1999 Arapaho Road Construction Shop
Drawings

Arapaho Rd Const Meeting

3-4-99

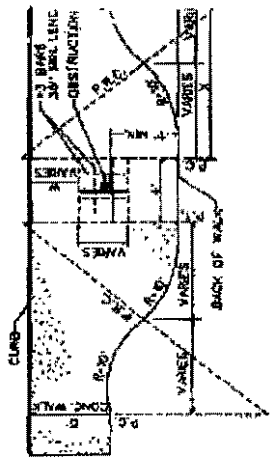
It is my understanding that the keyway on the back of curb is missing in some locations. The attached detail is an approved keyway substitute from the City of Dallas standard specifications. Unless you object, it is our intent to use this detail where the keyway is missing. Let me know. Thanks.

Gave verbal OK 2-24-99

CUSTOM CONCRETE BOLLARD

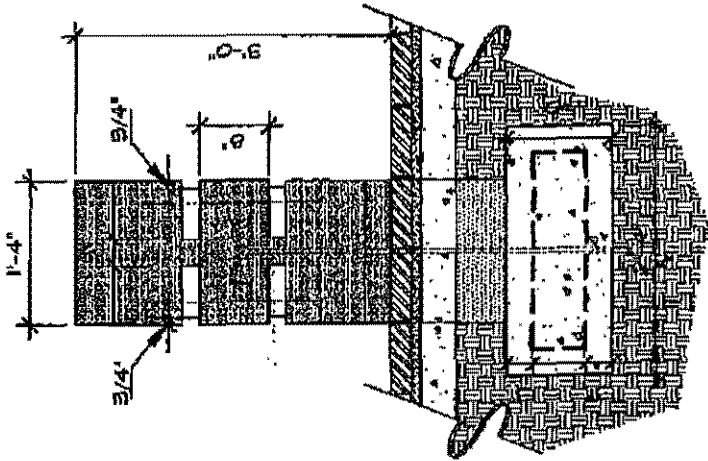
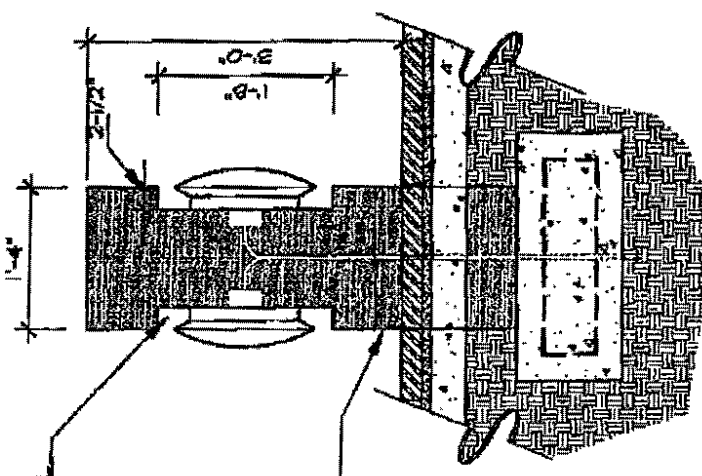
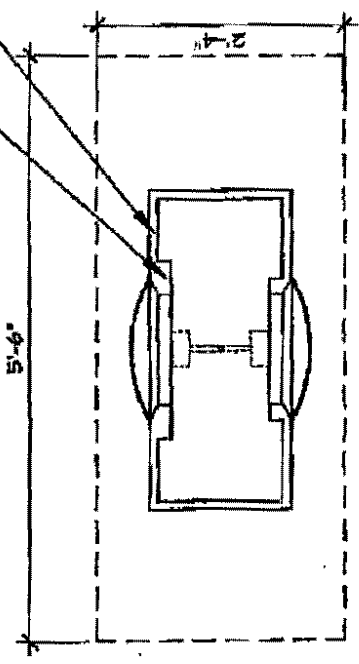
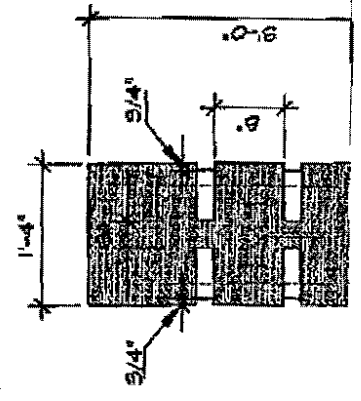
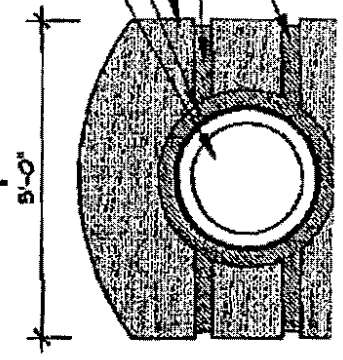
COMMENTS: FOLLOWING ARE THE REVISED DETAIL DRAWINGS FOR THE BOLLARDS & LIGHTS ON THE ADDISON STREETSCAPE PROJECT. PLEASE CALL IF YOU HAVE ANY QUESTIONS. THANKS.
There are pages including cover letter. Please respond if all pages are not received.

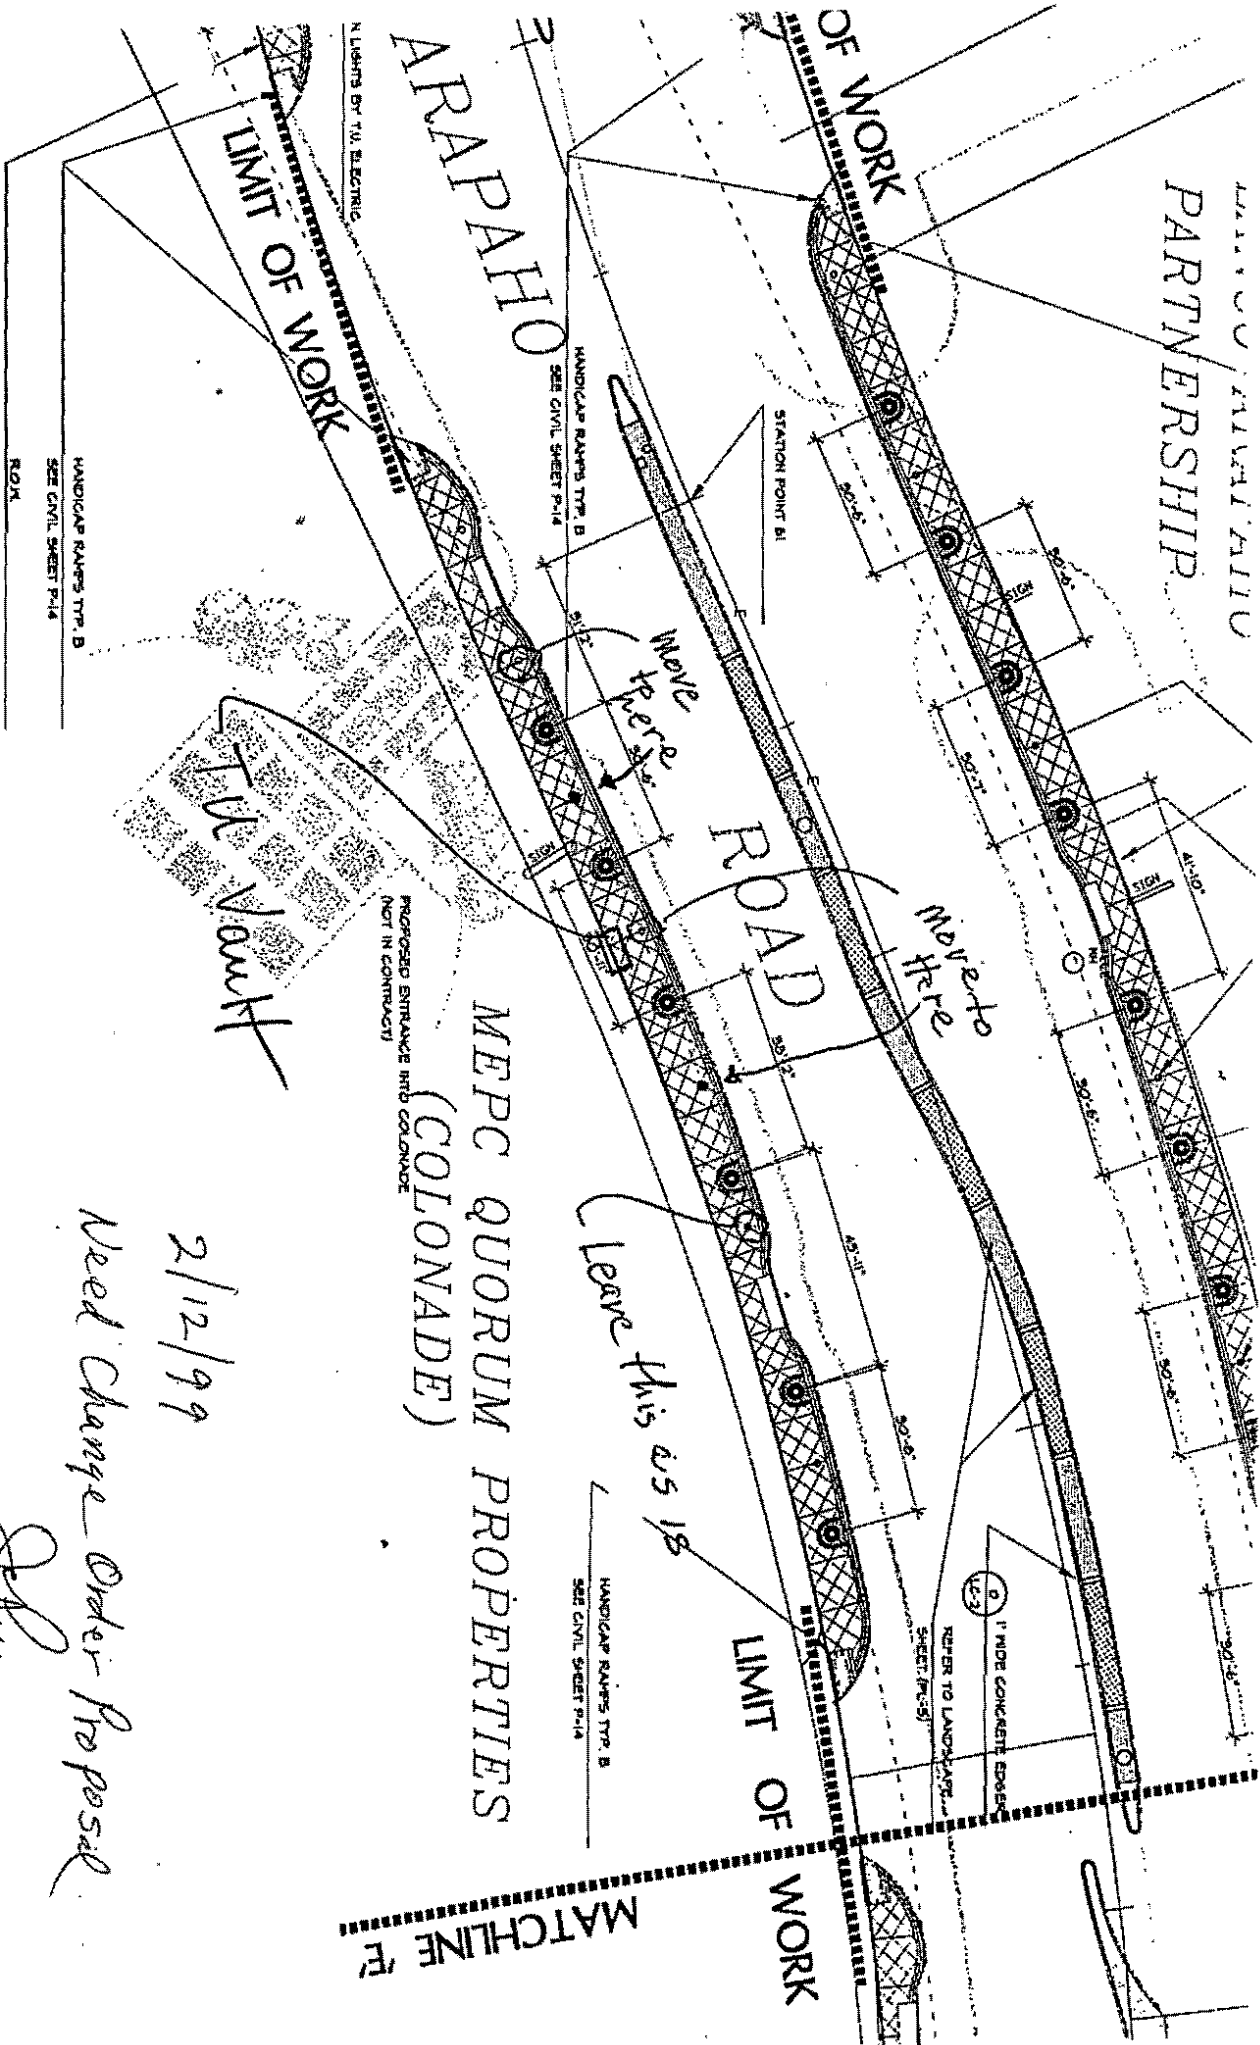
Comments: Because of the conflict with a
TU Vault (as shown on the attached)
two pedestrian lights need to be
moved/relocated as shown, all quant-
ities stay the same but this causes
additional electrical conduit work.

Please furnish a Change Order
proposal.

TV Vault

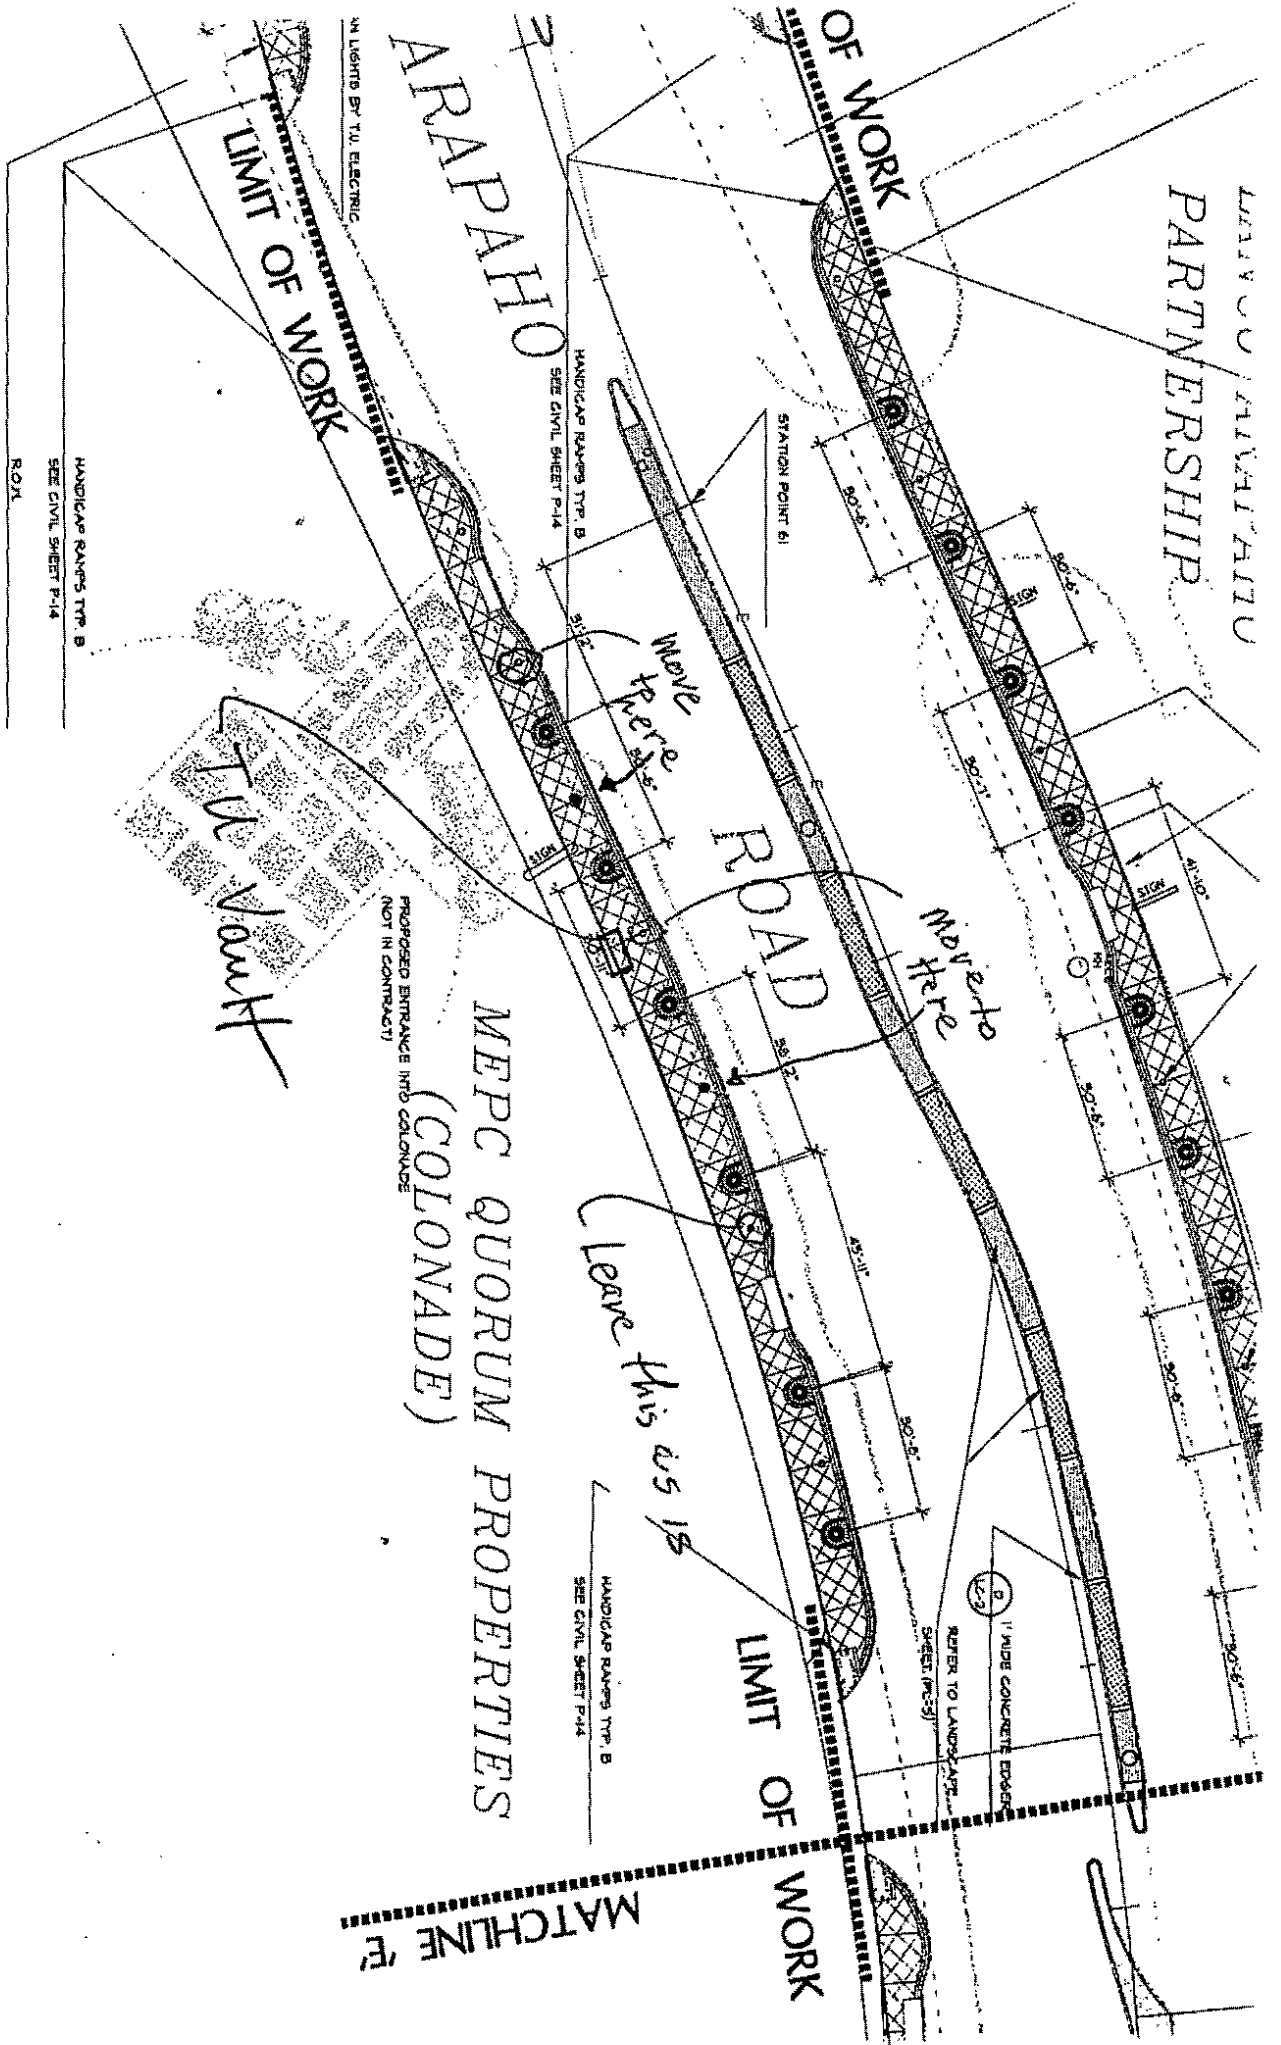
Leave this as is

Move to here

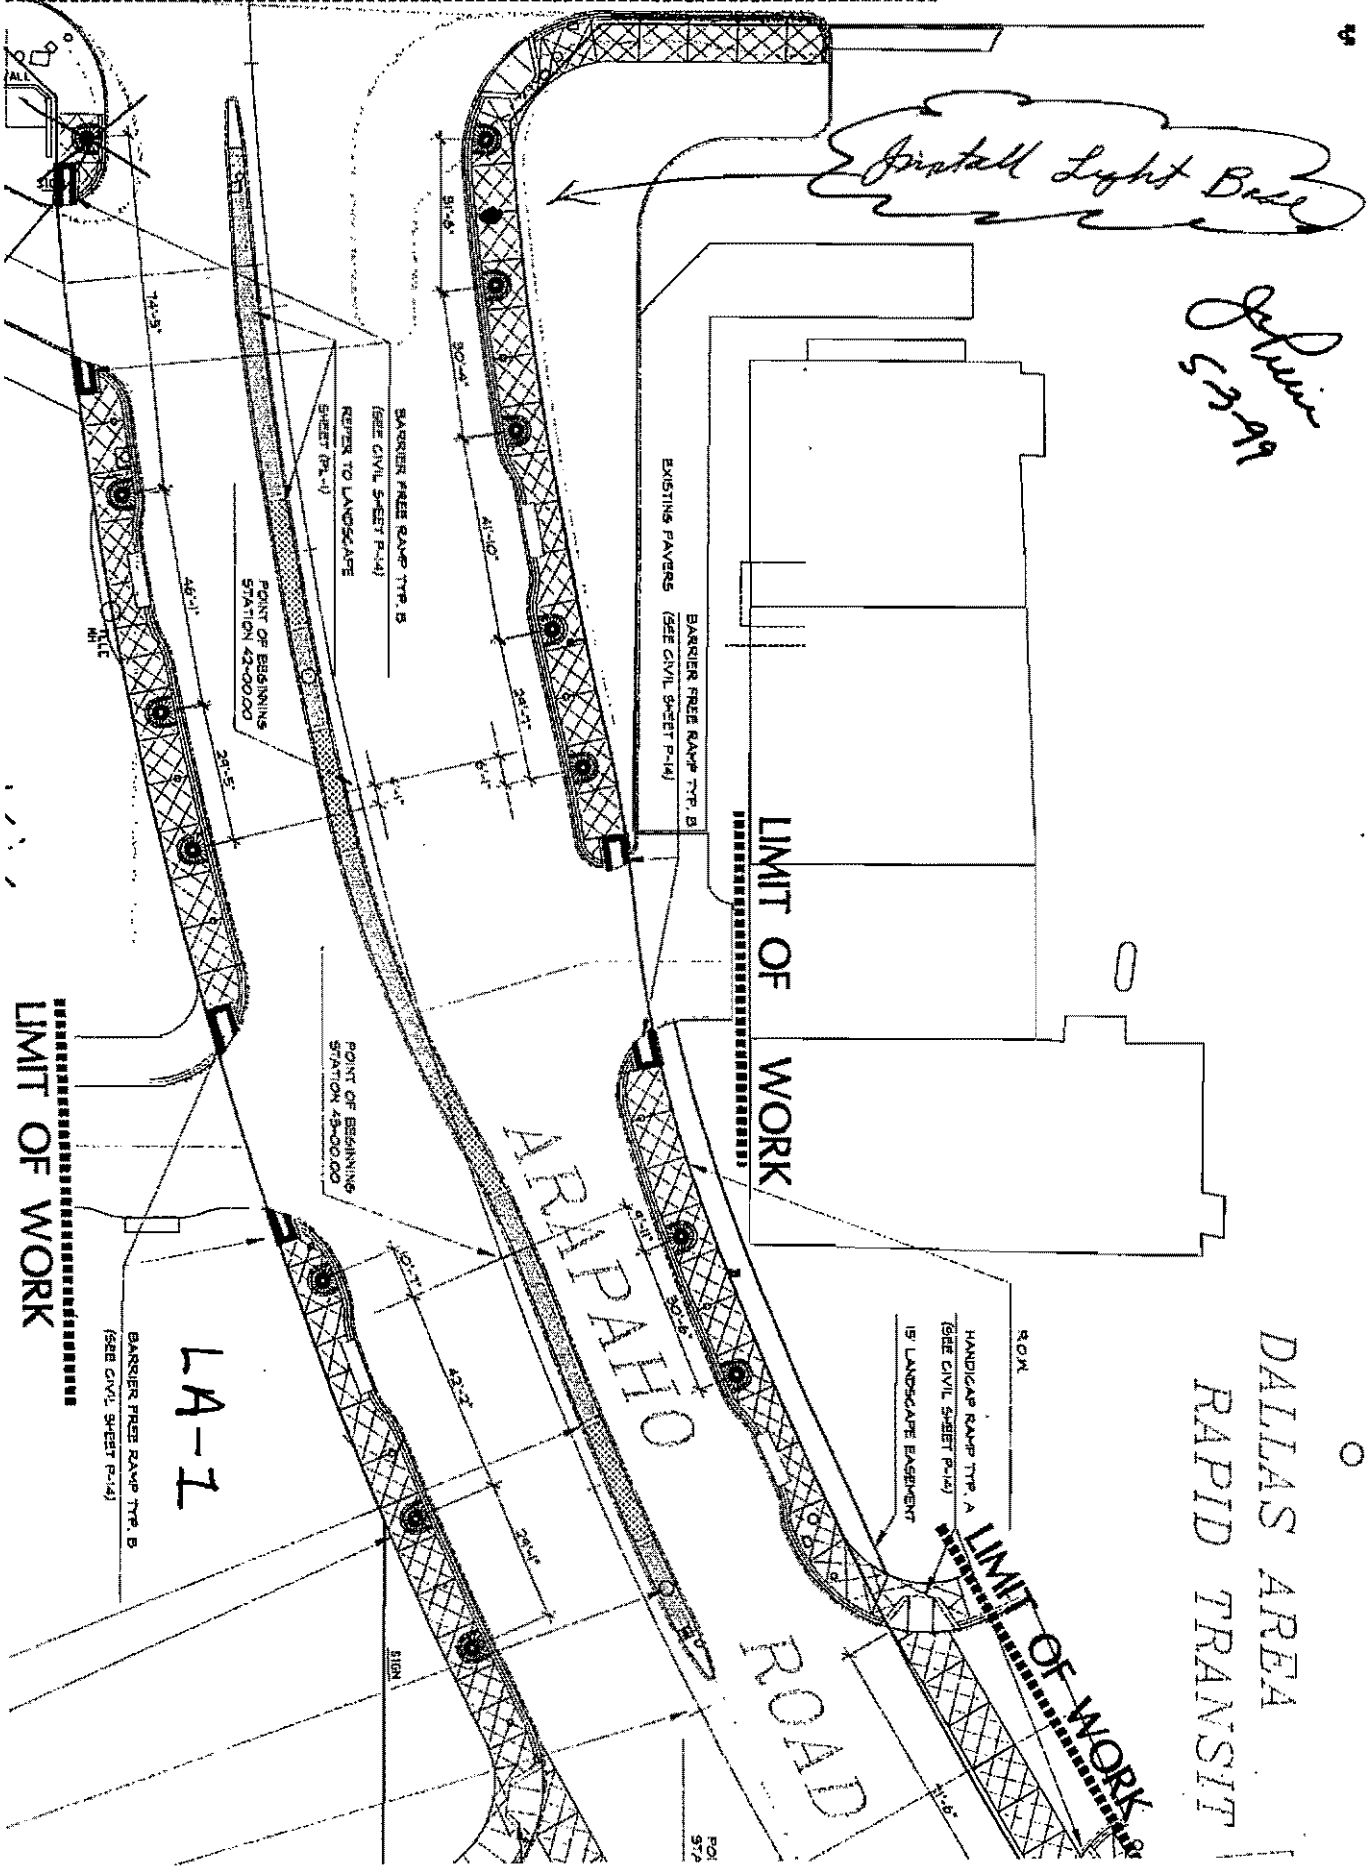
REMARKS Clarifies the conflict between Sheets LA-1 and SE-1. Generally, Sheet LA-1 controls. However, one light base & fixture was added to LA-1.

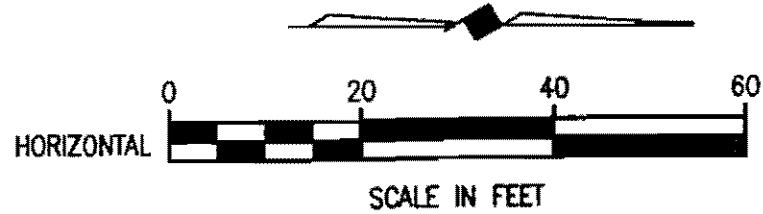
COPIES	DATE	NO.	DESCRIPTION
1			Sheet ST-10 Showing Spectrum Median
			Remarks (cont.) I have contacted Carr America to see if they will pick up the flower bed as part of their system. They will get back to me (yellow).

REMARKS Irrigation to the median (purple) is part of the contract. Irrigation to the median (green) has been severed. Irrigation to the median must be re-established either from the original source, or by extension of the project irrigation system. If the project system is extended, some redesign is needed to provide for the additional water needed, plus control valves. I suggest you use Irritech for this work.
